Rezoning Transportation Analysis

Petition Number: #2022-099

Date	Description
11-28-22	First Review (IW)
12-22-22	Second Review (IW)

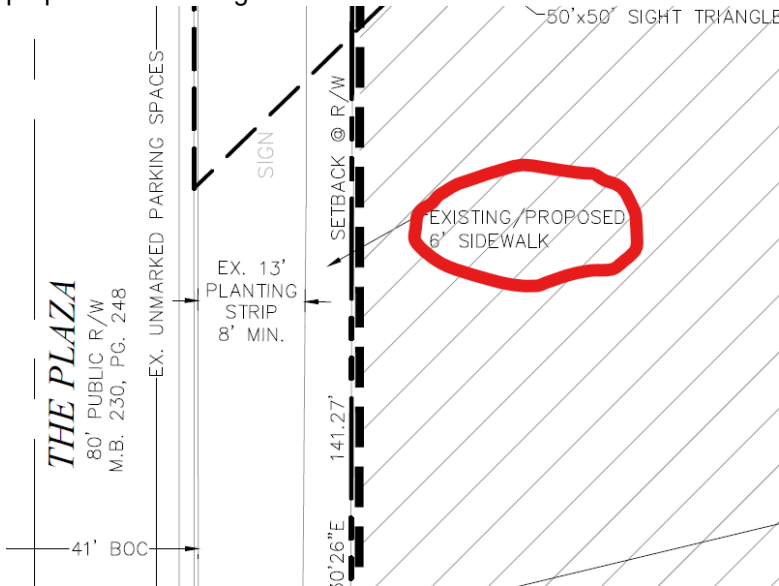
The Comprehensive Transportation Review was recently approved by City Council under the new UDO. In lieu of a TTM for the proposed site CDOT has requested the petitioner complete a CTR for the site. The petition's zoning falls within the medium to high intensity development which based on the 1,775 daily trips will trigger Tier 3 (14 mitigation points) for multimodal assessment and Tier 3 (6 mitigation points) for transportation demand management assessment.

The petitioner shall review and assess the publicly accessible pedestrian network within ¼ mile walking distance of the site to identify multimodal infrastructure to meet the Tier 3 (14 mitigation points) for multimodal assessment. Petitioner shall also provide transportation demand management strategies to meet Tier 3 (6 mitigation points) to reduce vehicle trips and encourage alternative modes of transportation.

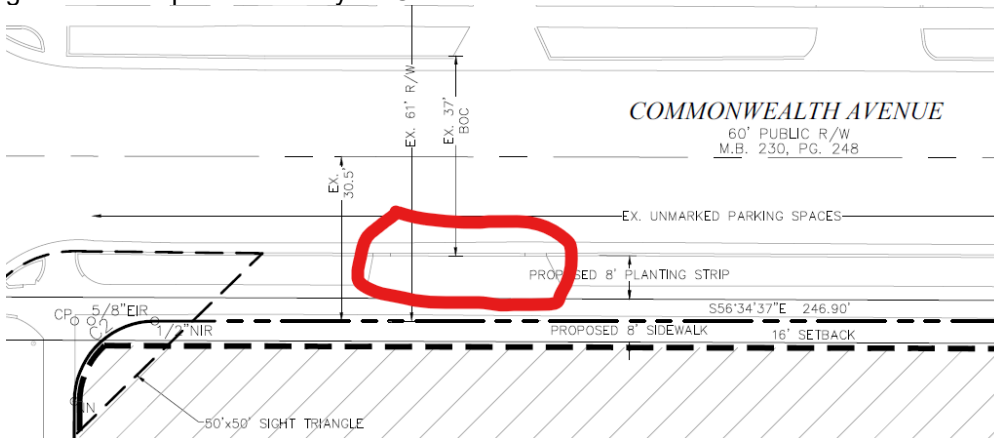
5. ~~Revise site plan and conditional note(s) to specify what portion of the sidewalk along The Plaza will be proposed vs existing.~~
